**SUBJECT: Approval of Moon, Stevens, and Rugg Brook TMDLs**

## EPA NEW ENGLAND'S TMDL REVIEW

**TMDLs:** Moon, Stevens and Rugg Brooks, Vermont

**DATE:** February 19th, 2009

**Figure 5.** High flow portion of the flow duration curves for Rugg Brook and attainment stream.

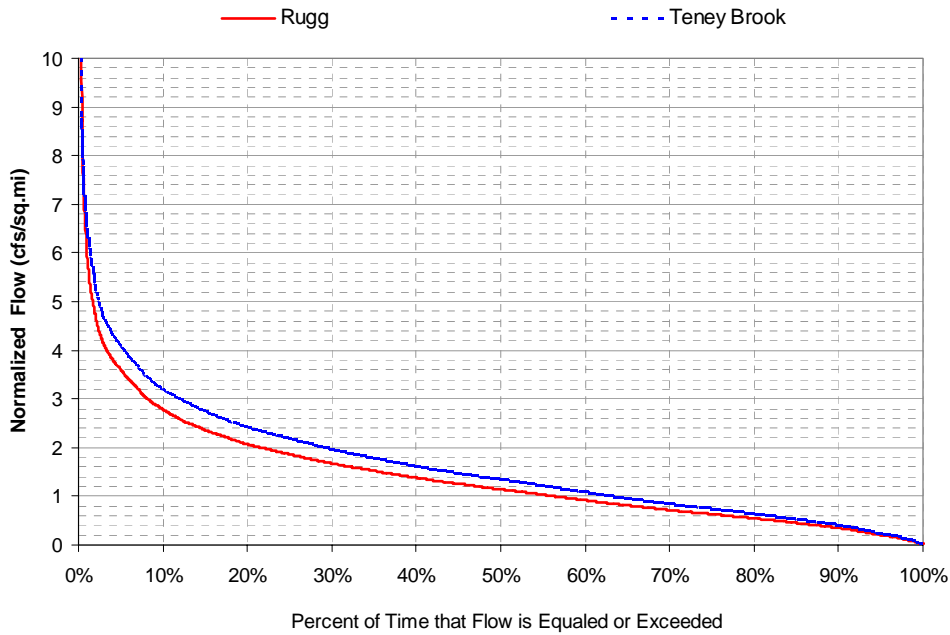
4. Page 14. The coincident of the graphs in Figure 5 does not seem to support a significant expenditure of resources to reduce stormwater related flows in Moon Brook. [Rutland]

Response: As noted in the TMDL, the high flow reduction target from current modeled conditions is 12%. Across the spectrum of the stormwater impaired streams for which TMDLs have been developed, this percent flow reduction is relatively modest. However, at this time watershed-specific implementation planning and cost estimates have not been developed to estimate the resources required to achieve this target.
